REGULAR MEETING AGENDA

**Preliminary Site Plan and Special Use Review
For
Ypsilanti Township, Michigan**

Applicant:	Zippy Auto Wash / Corey Weaver
Project Name:	Zippy Car Wash
Plan Date:	June 2, 2025
Location:	1822 W. Michigan Ave. (W. Michigan Ave. and Ellsworth intersection)
Zoning:	RC, Regional Corridor – Form Based District
Action Requested:	Preliminary Site Plan and Special Use Approval

RE: Zippy
Preliminary Site Plan Review #1

C-10

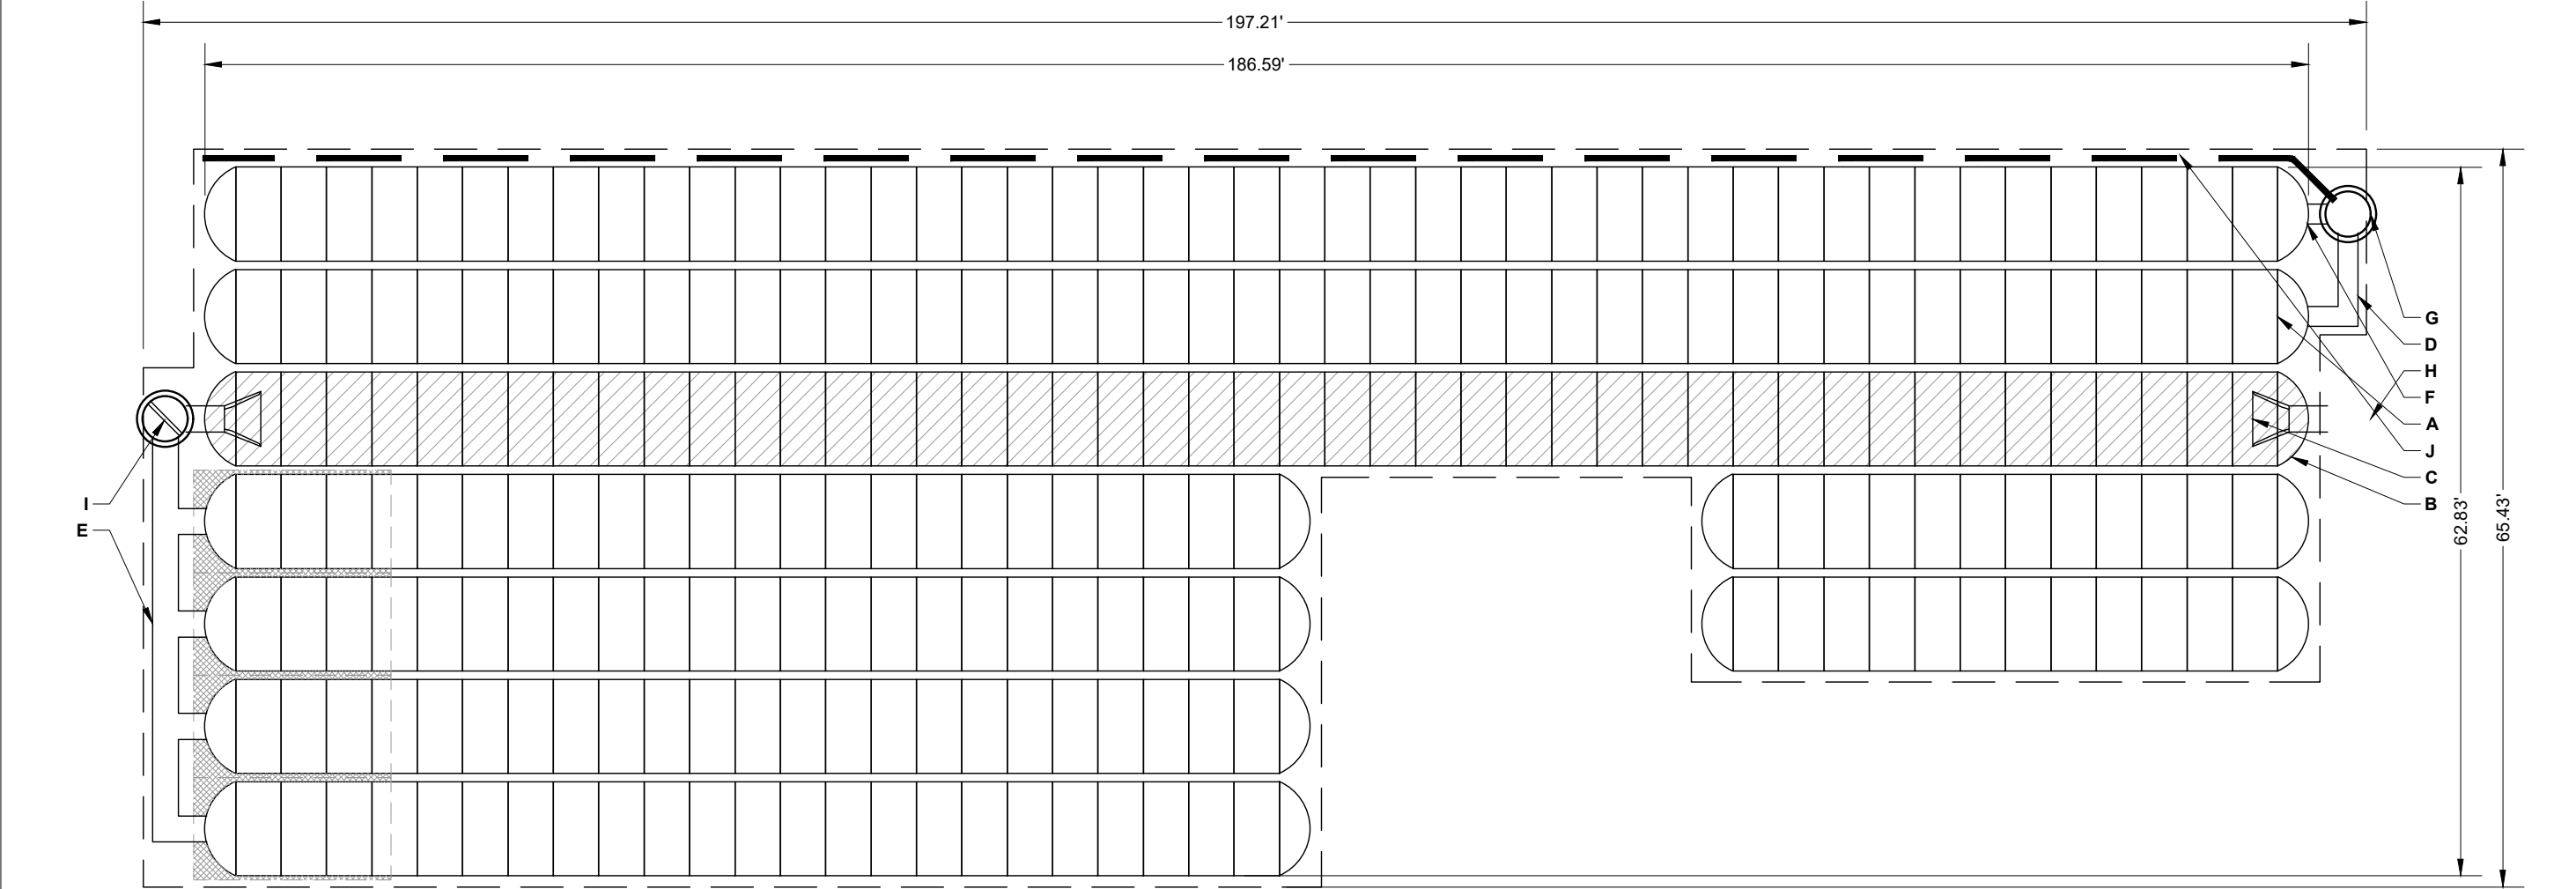
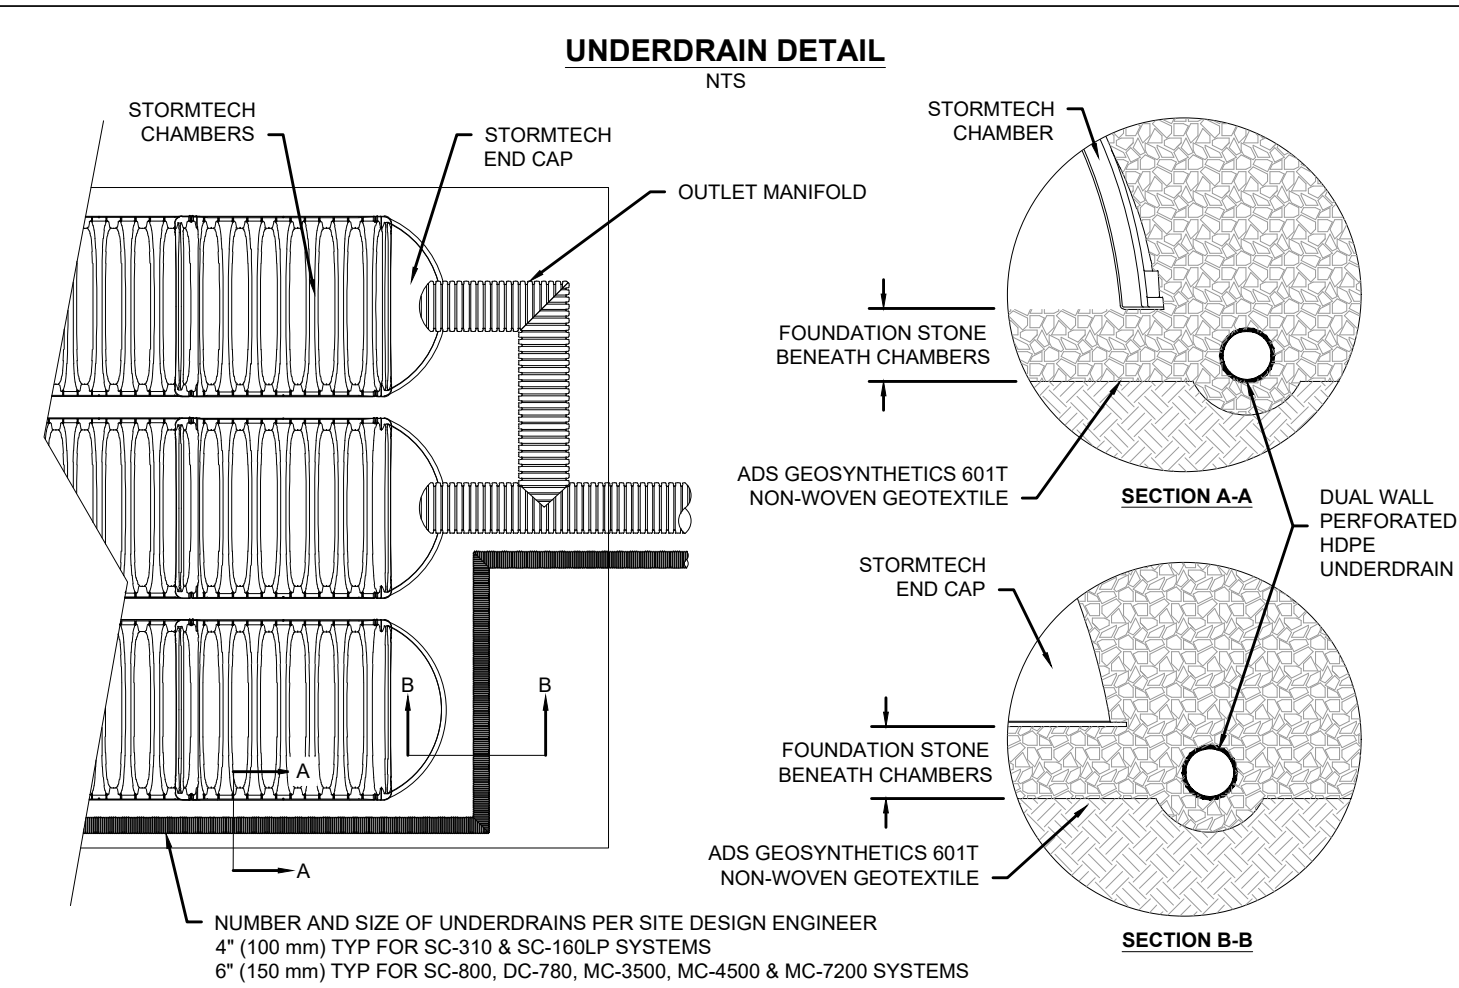
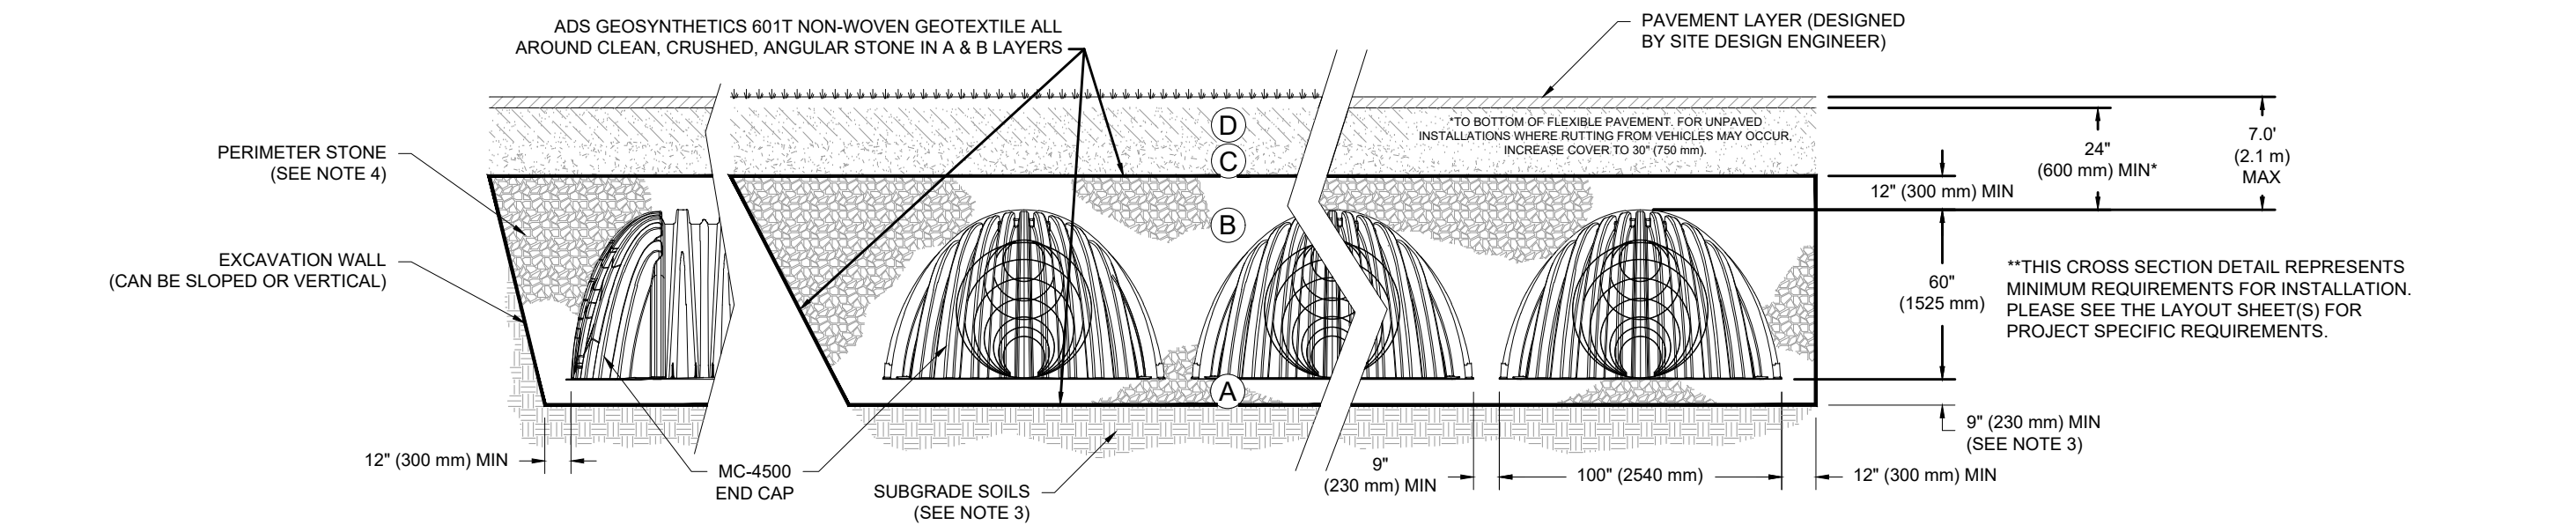
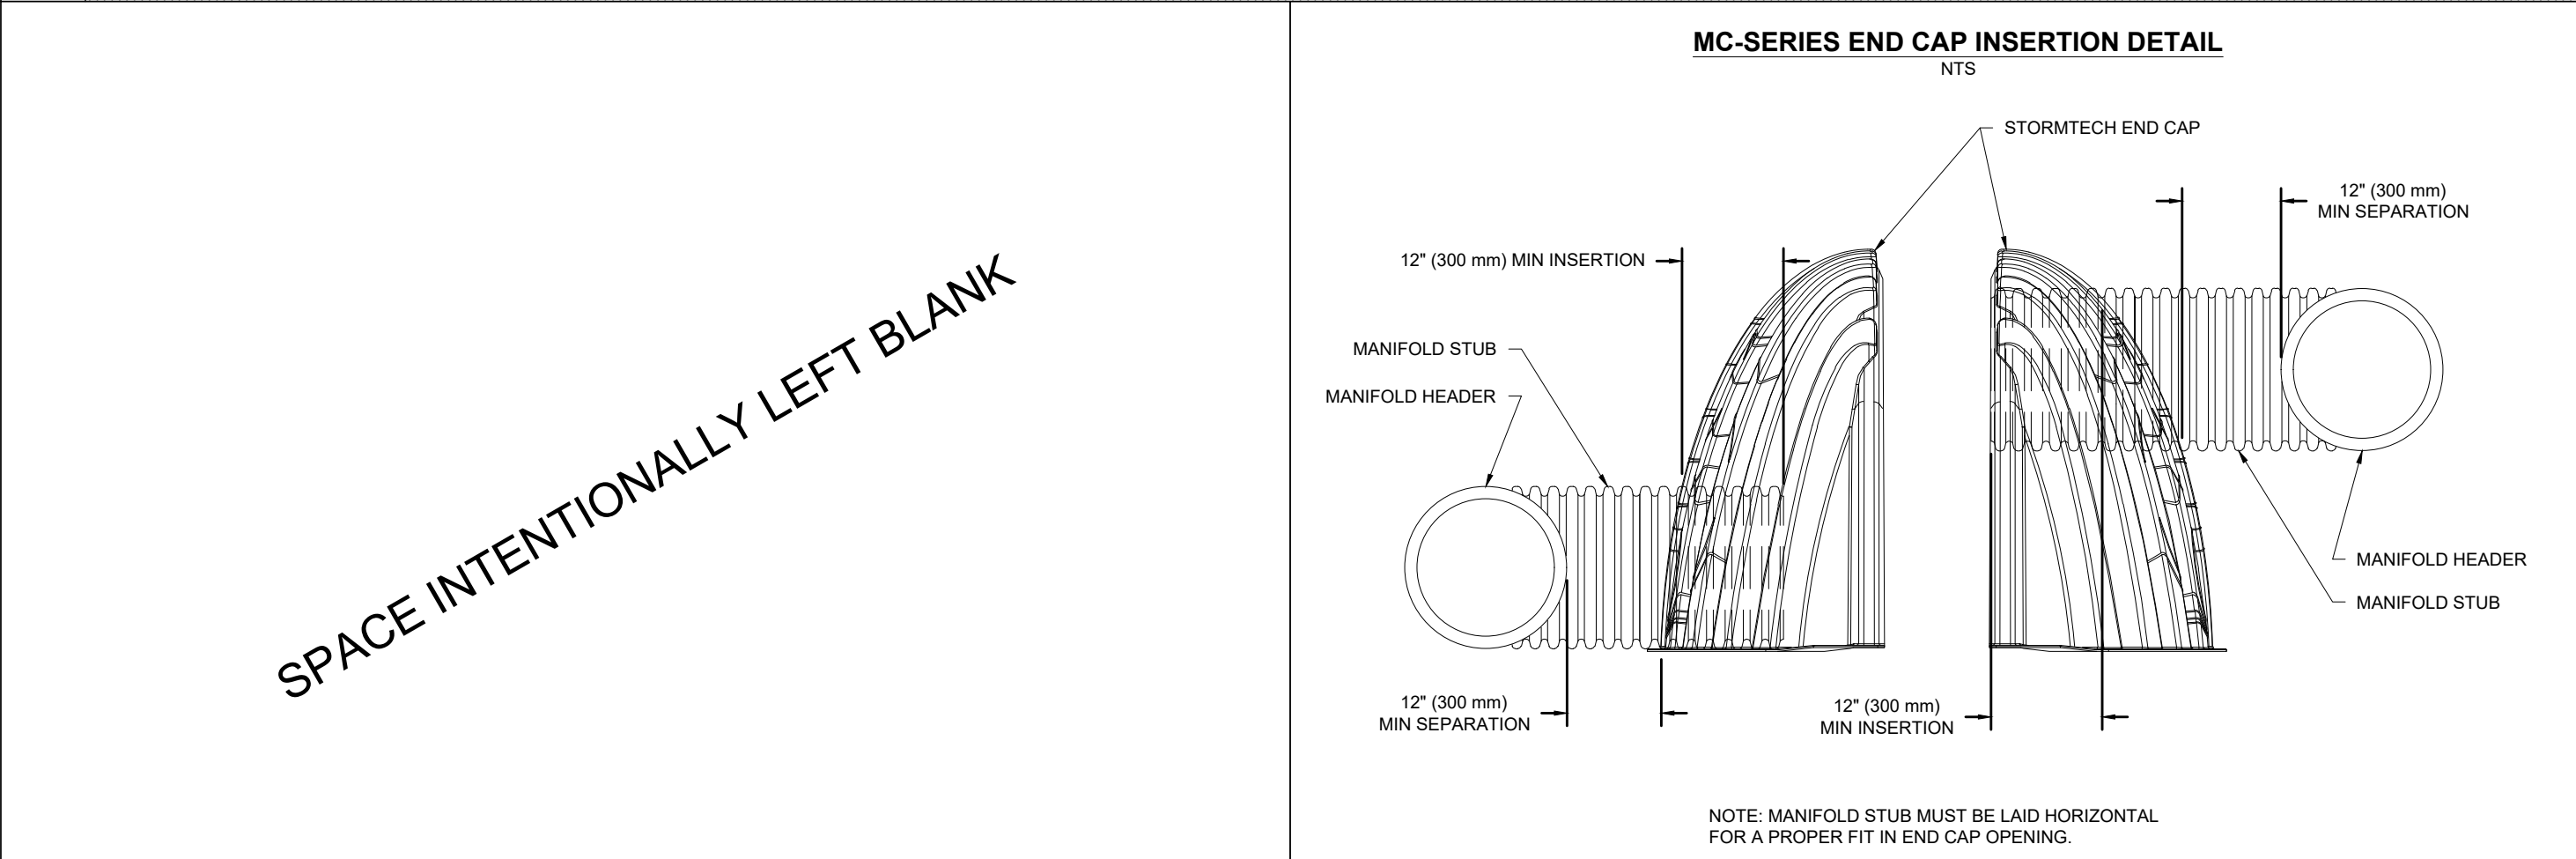
4. The applicant shall review and revise the outlet orifice calculations as it currently appears the minimum time of detention for the first flush storm (24 hours) was not met. The applicant shall update all subsequent calculations accordingly.

8. The applicant shall include the heated slab with the trench drain within the maintenance schedule(s). The applicant shall also remove the wetlands and other components from the maintenance schedule(s) that are not present on-site for clarity.

9. The applicant shall note that storm sewer pipe shall be RCP C-76, per Township Standards, or the load carrying design analysis for use of other materials for the proposed depth conditions shall be provided on the plans.
